CLARK COUNTY, NEVADA BID NO. 603390-14 SPENCER STREET, WINDMILL LANE TO WARM SPRINGS ROAD & SERENE AVENUE, SPENCER STREET TO EASTERN AVENUE

August 19, 2014

ADDENDUM NO. 1

SPENCER STREET
DETAIL SHEET

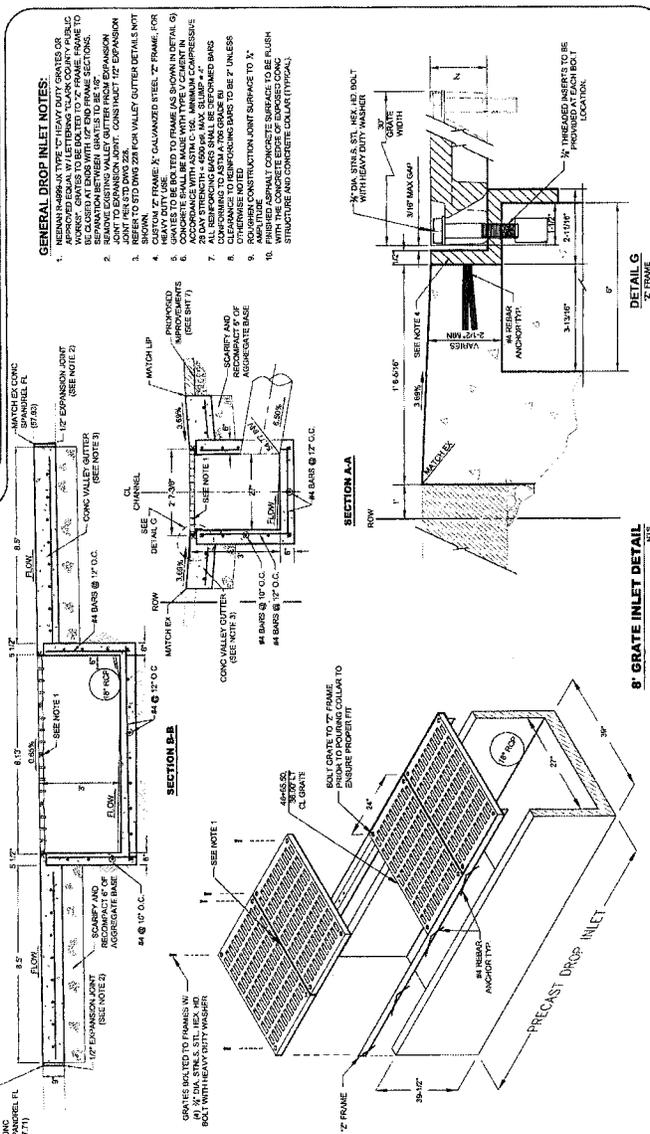
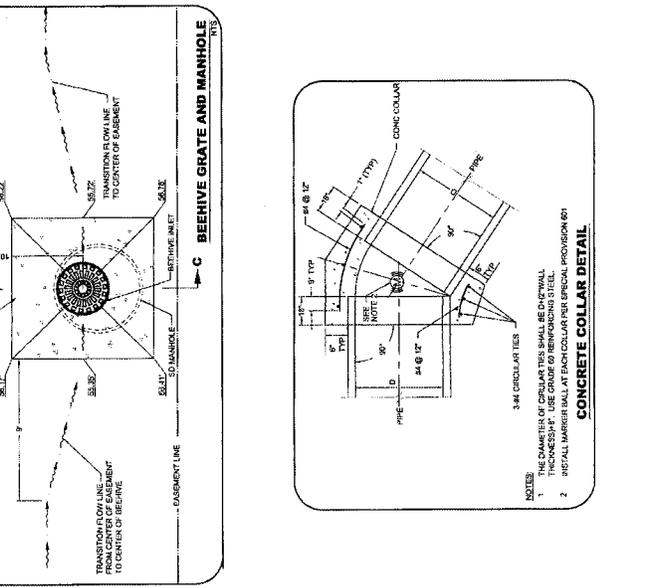
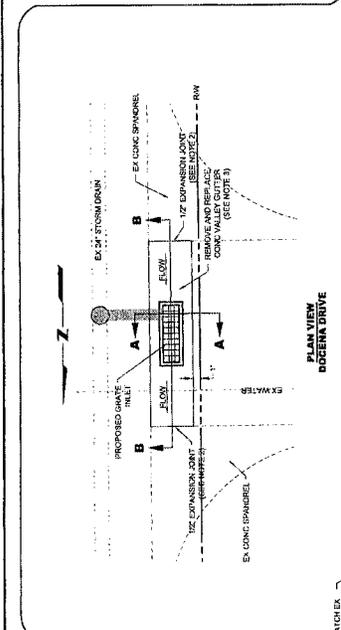
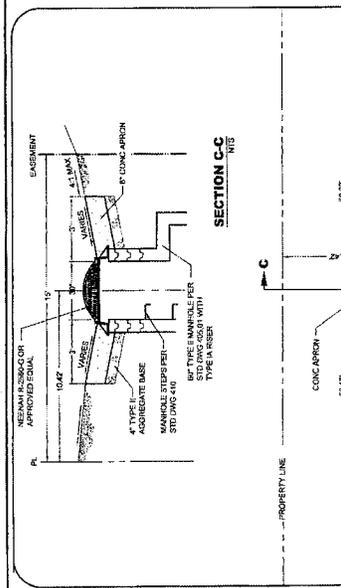
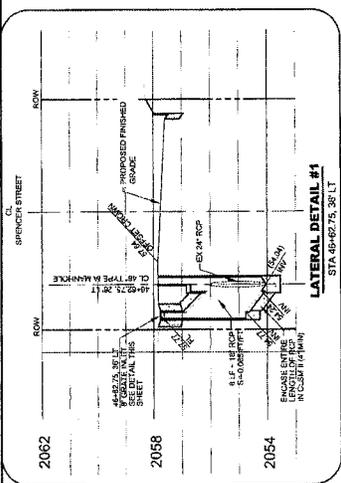
2. *The following sheets are being reissued with this addendum.*
 - a. SHT – 9: Revised 8' grate inlet detail; inlet changed from cast-in-place to precast. Elevations on lateral detail 1 have been changed to coincide with elevations on plans.
